DEVIATION REQUEST AND DECISION FORM

Project Name : Trails at Aspen Ridge Filing No. 2
Schedule No.(s) : 5500000412
Legal Description : Unplatted Land

FILING NO. 2
ROADWAY & STORM IMPROVEMENT PLANS

ROADWAY PLAN & PROFILE

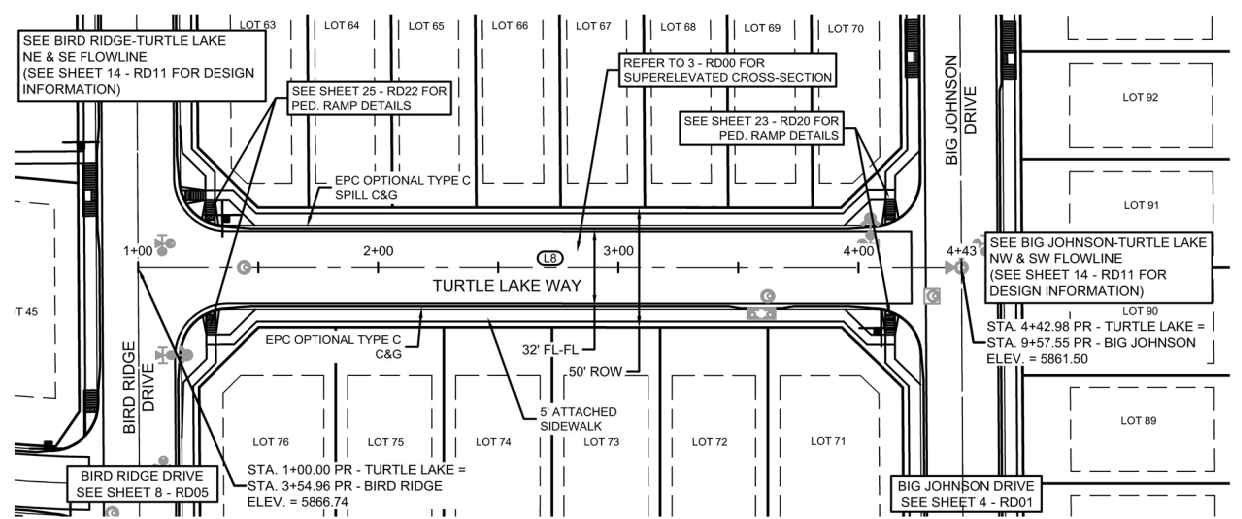
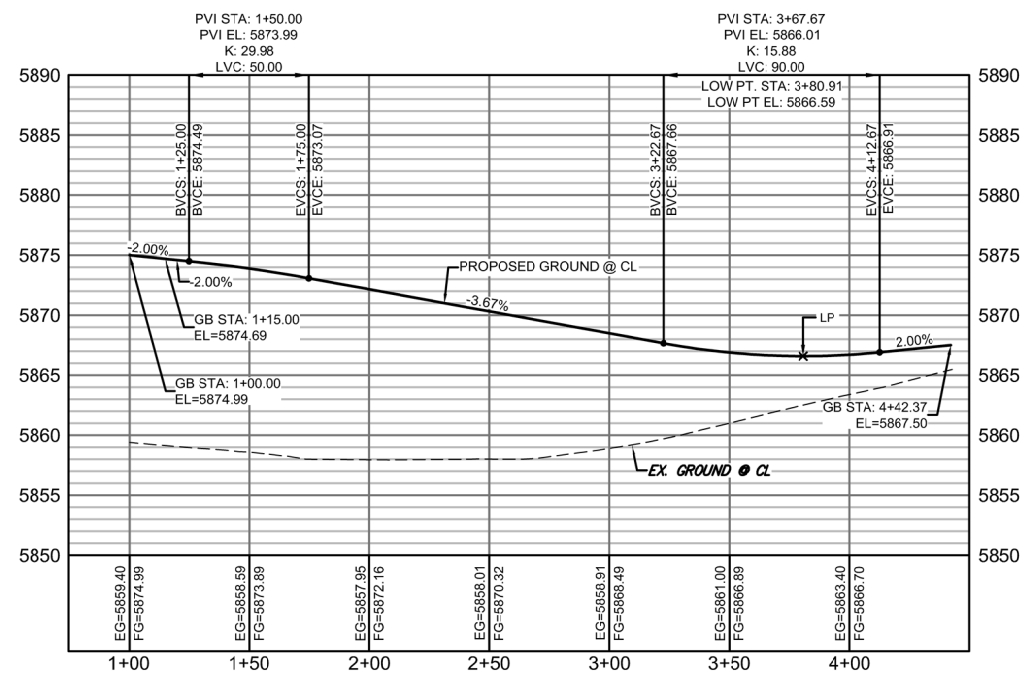
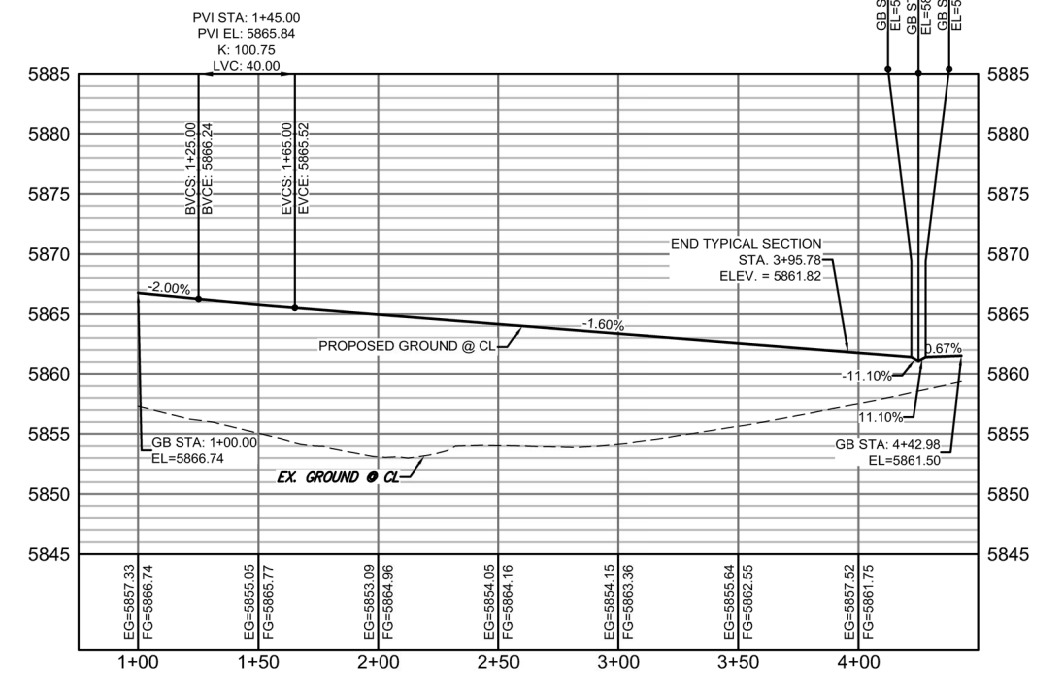
Transitioning from warped intersections on the west and east ends to a typical, crowned section on Nutterbutter Point and Turtle Lake Way is impractical due to the short lengths of these roads.

In order to return to a crowned intersection and not superelevate the roadways of Turtle Lake Way and Nutterbutter Point, the rate of transition of grade would exceed comfortable and safe driving conditions. To mitigate this problem, the roads previously listed have maintained a superelevated cross section ranging from 2% to 5%.

In order to meet the intersecting roads of Big Johnson and Bird Ridge (4%-5%), the east and west ends of Turtle Lake Way and Nutterbutter Point have been warped. Using a transition of 1% in 25', it is impossible to get back to a typical crowned section for either road due to the shortness of length. Maintaining a superelevated section allows for comfortable and safe driving conditions.
